ARM
L220 Level 2 Cache Controller (AC131)
Errata Notice

This document contains all errata known at the date of issue in releases up to and including revision r1p7 of L220

Date of Issue: March 13, 2009

Figure 1: Implementation workaround for 401552 erratum when the L220 MBIST interface is used

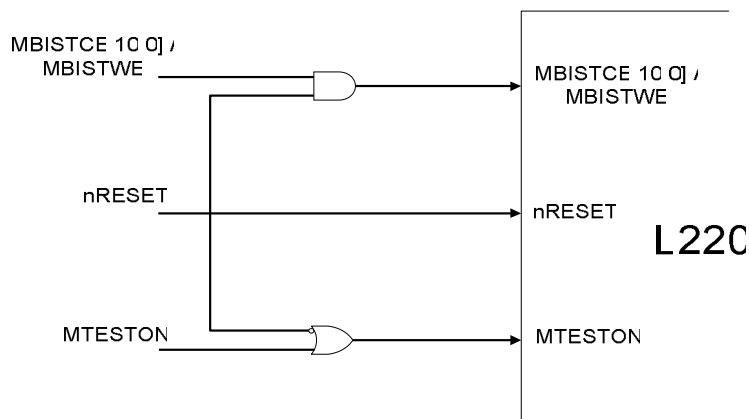
The registers mbist_ce_reg[10:0] and mbist_we_reg declared in the L220_bist_if.v verilog file are not reset. As a result, they have an unknown value (1'bX in simulation, VDD or VSS on silicon) after the L220 cache controller has been reset. However, the output of these registers is used to control some RAM output signals in L220_cache_ctl.v, even if the MBIST mode is not enabled (i.e. in functional mode).

On silicon, the value of uninitialised registers is unpredictable. If the output of the mbist_ce_reg[10:0] and mbist_we_reg registers is not VSS when the power is turned on, failures (incorrect values driven to the RAMs) occur in functional mode. Under these circumstances, this means that L220 cannot be enabled.

There is one possible workaround for this erratum. Before L220 is enabled, e.g. during the reset sequence of L220 (nRESET asserted LOW), MTESTON can be driven HIGH for at least one clock cycle while MBISTCE[10:0] and MBISTWE are driven LOW. This allows propagating known and inactive values to the output of the mbist_ce_reg[10:0] and mbist_we_reg registers.

- if the L220 MBIST interface is used

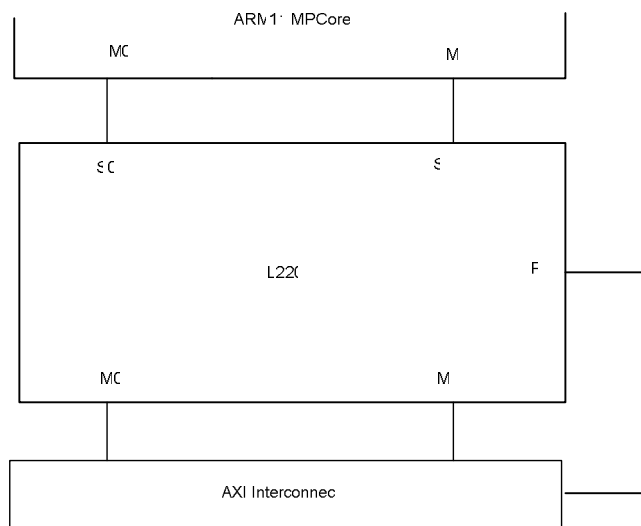
Certain L2 cache maintenance operations and accesses to the Peripheral port only start when the L220 Write Buffer is empty. Their corresponding write response is only sent on AXI when the operation is complete or the access has taken effect.

4. The write access is forwarded to the M1 L220 AXI master port, is issued on AXI and goes through the L3 interconnect.
5. It is received by the L220 Peripheral port.

6. The Peripheral port sends a drain request to the Write Buffer.
7. The Write Buffer (WB) starts draining and sends a request to M1.
8. M1 cannot issue the WB request on AXI as it is busy with the Peripheral port write access.

Under the conditions listed above, a deadlock occurs.

If the system connectivity is exactly as described in the figure below (note the M0 → S0 and M1 → S1 connections between ARM11 MPCore and L220 and the 2slaves/2masters configuration for L220),

If the connection from the Core to L220 peripheral port is through the L220, but the system connectivity is not exactly the same as in the figure above, the workarounds are the following ones:

- Replace the Cache Sync operation by a dummy SWP to a cacheable or non-cacheable memory area that will go through one of the two main L220 slave ports (S0 or S1). The AXI locked transactions received by the L220 slave ports are only treated once all buffers are empty, thus acting like a Cache Sync. This dummy SWP must not target the L220 Peripheral port, see erratum 533267 for more information.
- Replace the Clean and/or Invalidate by PA or Index/Way operations by Clean and/or Invalidate by Way operations.

**Figure 3: Implementation workaround for 391290 erratum**

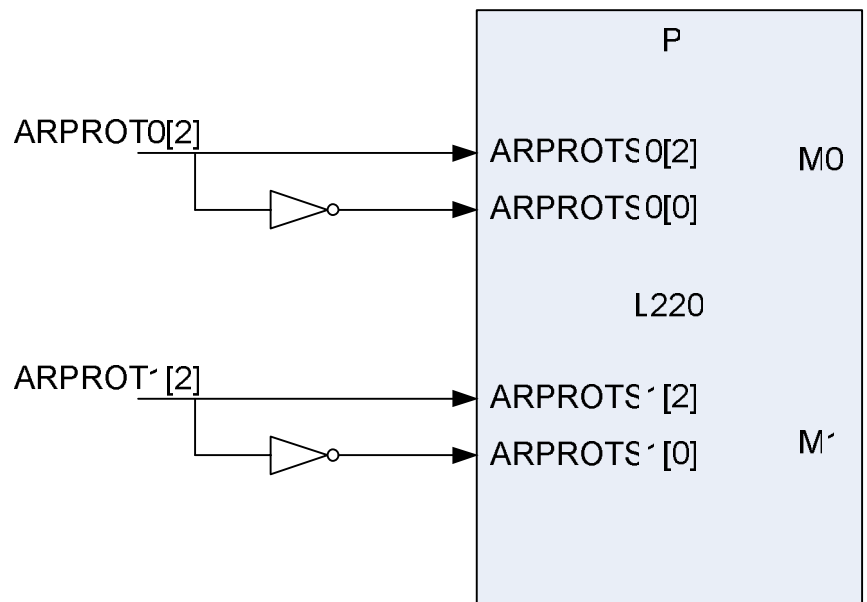
391290: The L220 does not make correct distinction between data and instructions for cache lockdown

1. The Instruction and Data Lockdown registers have different programmed values.
2. An instruction (resp. data) linefill marked with ARPROTMx[2] = 1'b1 (resp. 1'b0) is issued by one L220 AXI master port.
3. When the AXI read transaction is complete, the master sends a request to the cache controller for allocation.
4. The master erroneously gives the inverted value of ARPROT[0] to the cache controller instead of ARPROT[2].
5. The cache controller might thus consider the wrong Lockdown register for allocation and incorrectly choose the victim way.
6. The cache controller might then erroneously allocate the line in a locked way.

This is not possible to configure L220 to make a distinction between instructions and data as far as the cache lockdown mechanism is concerned. The two Data and Instruction Lockdown registers must be programmed with the same value.

There is a possible implementation workaround for this erratum. Indeed, ARPROT[0] indicates if the read transaction is normal or privileged. This information is not used within L220 and can only be relied upon at L3 level in case of Strongly Ordered or Device accesses. If ARPROT[0] is not used by the L3 memory system in that context, it is possible to workaround the erratum described above by connecting ARPROT[2] to the ARPROT[0] input on the L220 slave ports, as described in the figure below.
